From: Breeze, Gordon <Gordon.Breeze@bregroup.com>
Sent: 16 September 2020 10:16
To: Markwell, Jonathan <Jonathan.Markwell@reading.gov.uk>
Cc: Blackmore, Paul <Paul.Blackmore@bregroup.com>
Subject: 53-55 Vastern Rd, Reading (200188) BRE Project P117633 (BRE response to RBC)

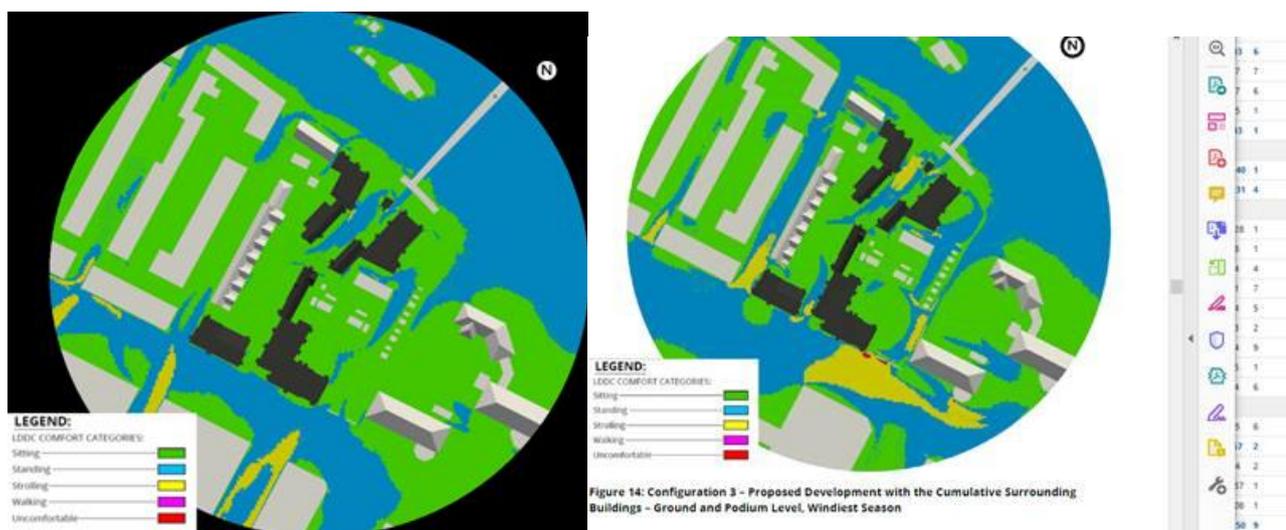
Issue A) We were unaware that the main doorway is located on the East façade of the Sovereign House south hemispherical extension. Given this main doorway location, we agree with the RWDI comments about this doorway, and we also think a comment in their report would be appropriate to clarify this matter. As well as this matter there is a small location to the south of the aforementioned extension which is shown as red (unsuitable for walking and all other more sedentary activities). Our concern is that this location is not suitable for any pedestrian activity and should be mitigated. The discussion of the windy area outside Sovereign House is only relevant to Configuration 3.

As can be seen from the image above, if the development is as per configuration 4 then there are no wind issues at this location. Furthermore, if Configuration 3 is built first followed by Configuration 4, then the Configuration 3 windy areas (shown above) would only exist temporarily until Configuration 4 is constructed.

We think that this issue should also be commented upon by RWDI in their report and if Configuration 3 will be built then it should be demonstrated that the proposed mitigation measure will ameliorate the windy conditions at the 'red' location near Sovereign House.
